MZM (CEPZ) Ltd. (11782)

Plot # 8-9, Sector # 2/A, CEPZ, Chittagong-4223

Identified Priority 1 Concerns

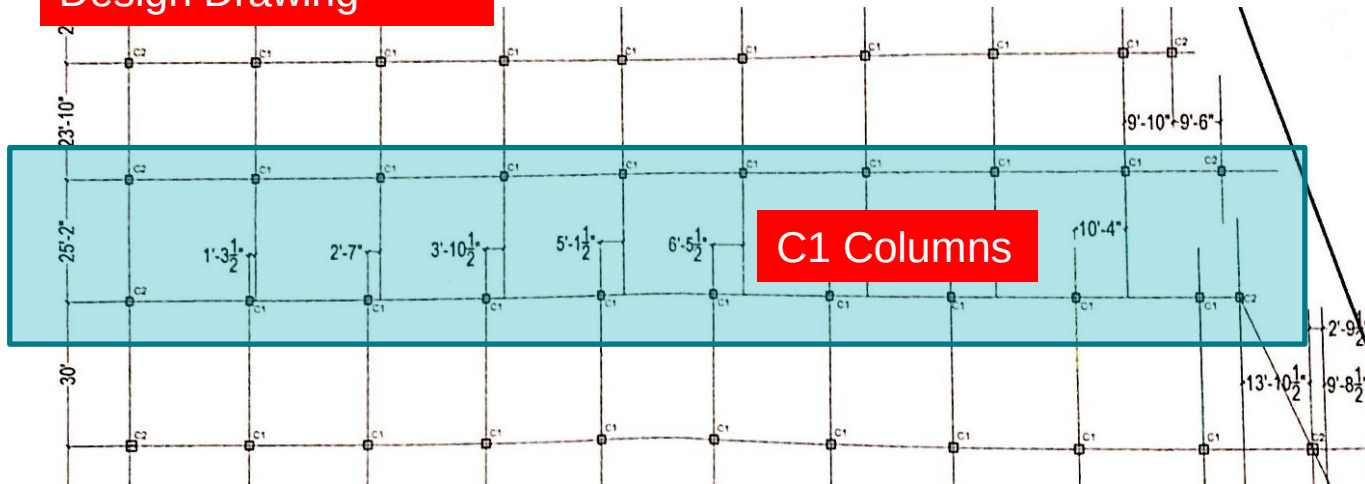
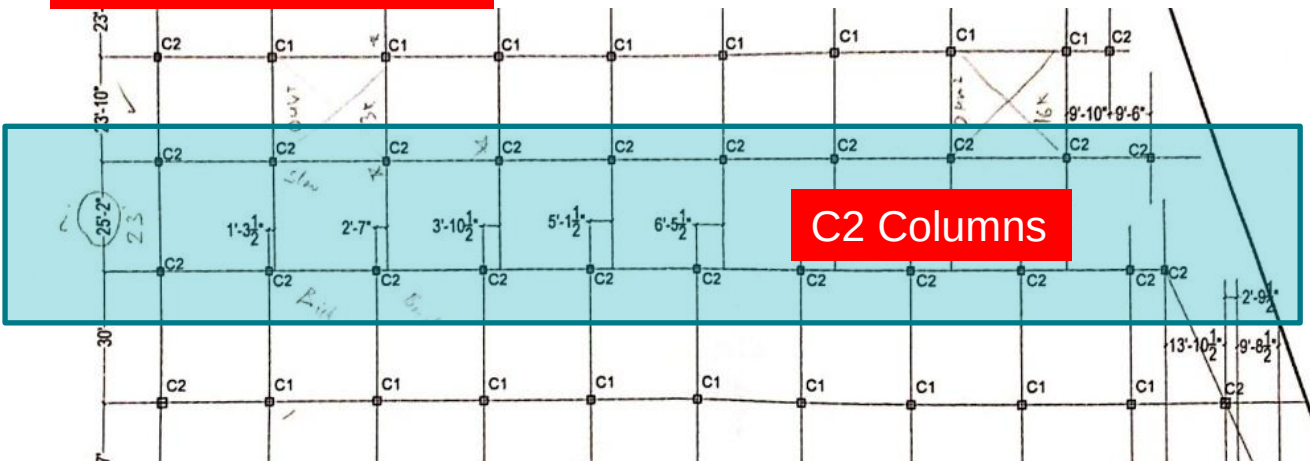
The column types changes between the Design Drawings and the “As Built” drawings along the central section of the building.

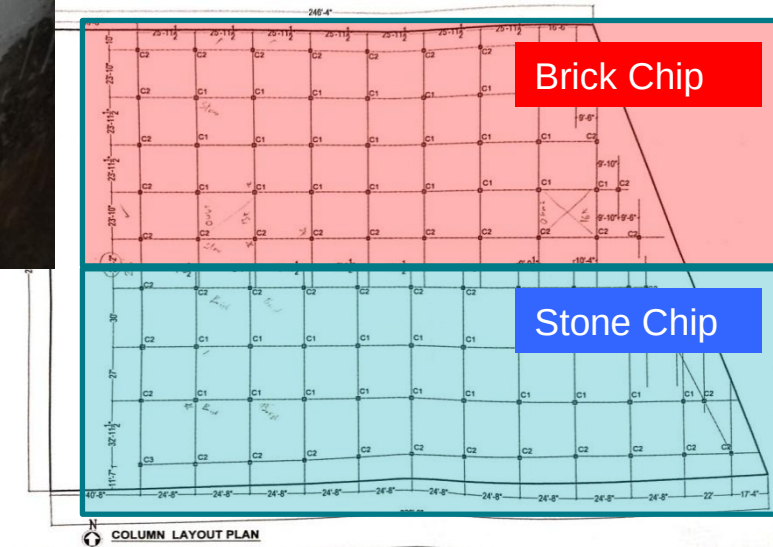
The coarse aggregate in the columns differs from brick to stone throughout the building.

The drawings detail stone chip to all columns.

It would appear that the North part of the building uses brick chips and the South part uses stone chips based on our limited intrusive survey. It would be necessary to check more columns at all levels to determine which columns use brick aggregate.

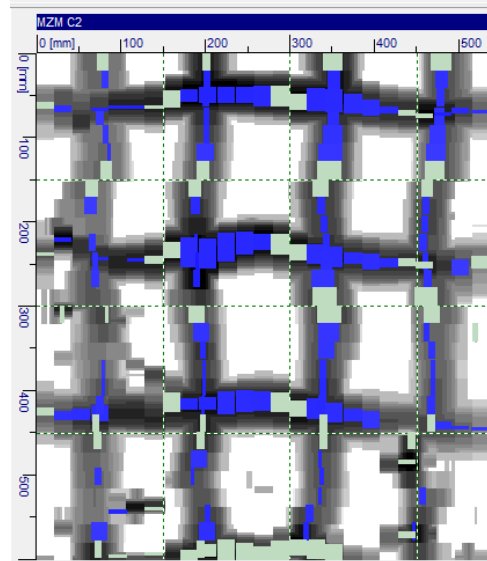
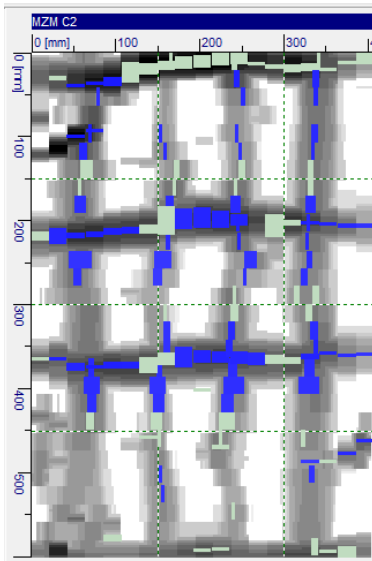
The reinforcement discovered during the Ferro-scanning did not match the structural “As Built” drawings.

The scans for the C2 column (left) clearly show 12N° 25mmØ bars. While the drawings show 14 N° 25mmØ bars.

The scans for the C2 column shows 16N° 25mmØ bars. While the drawings show 24N° 25mmØ bars.

3rd Priority 1 Concern

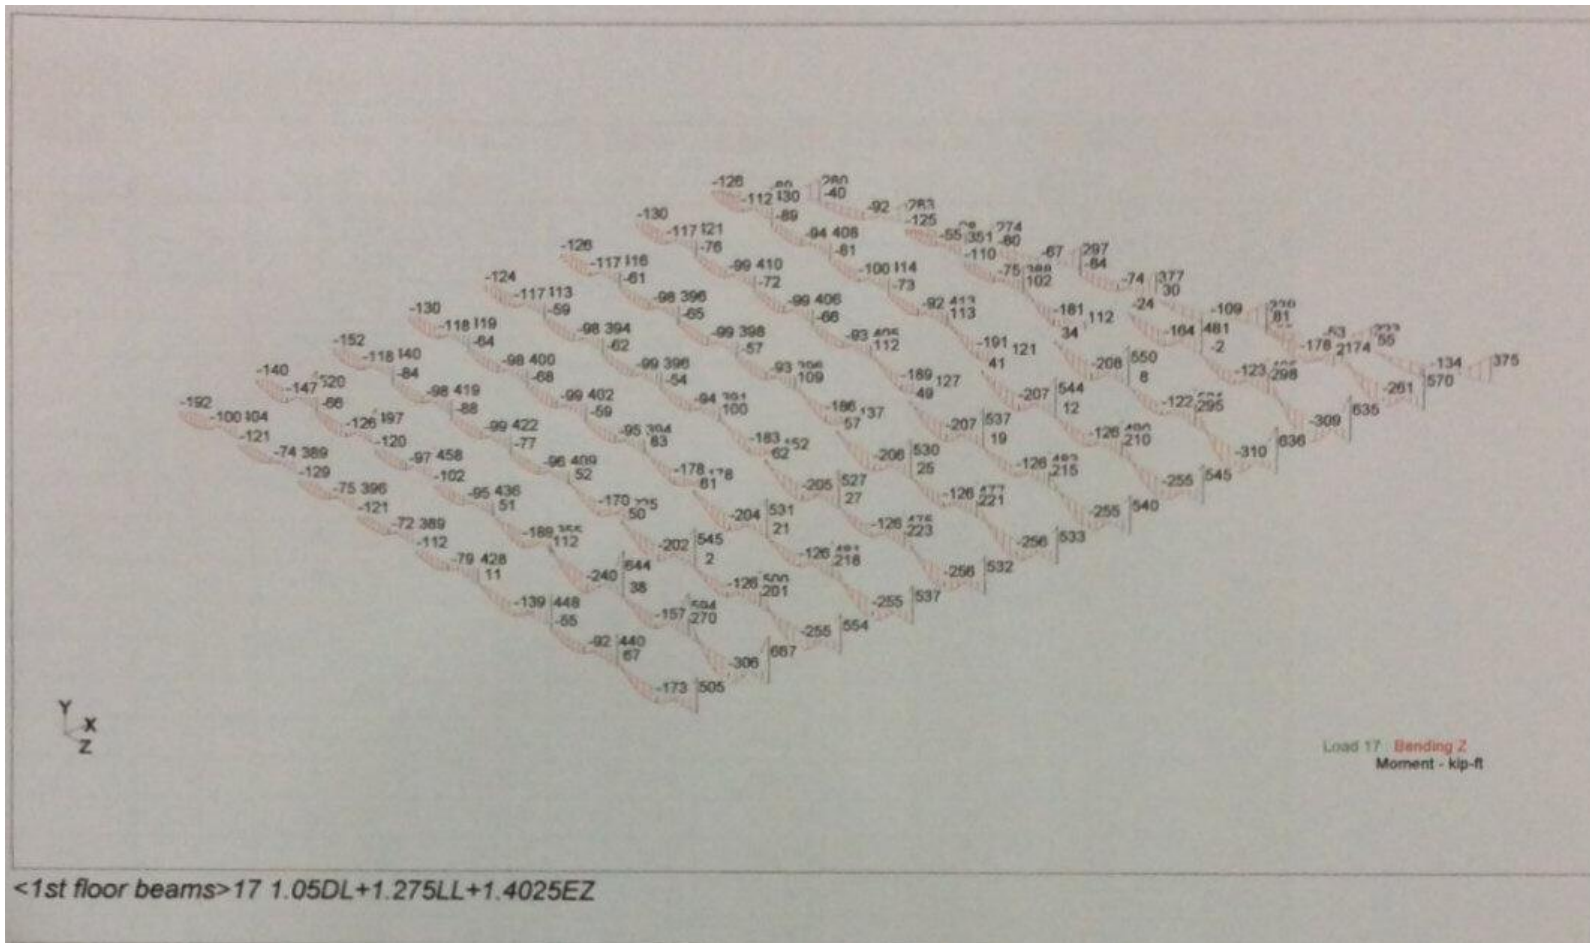
The allowable loading for the building is unknown

We were advised that the floors were designed for 80psf. Given the columns have been constructed considerably smaller than the original design the allowable loading will be greatly reduced.

Plinths have been constructed around the toilets at 1st floor, we recommend that the increase in dead load is also checked as part of the Detailed Engineering Assessment.

We would advise that the suspended floors are not loaded above 40psf (2.0kPa) until a Detailed Engineering Assessment is undertaken.
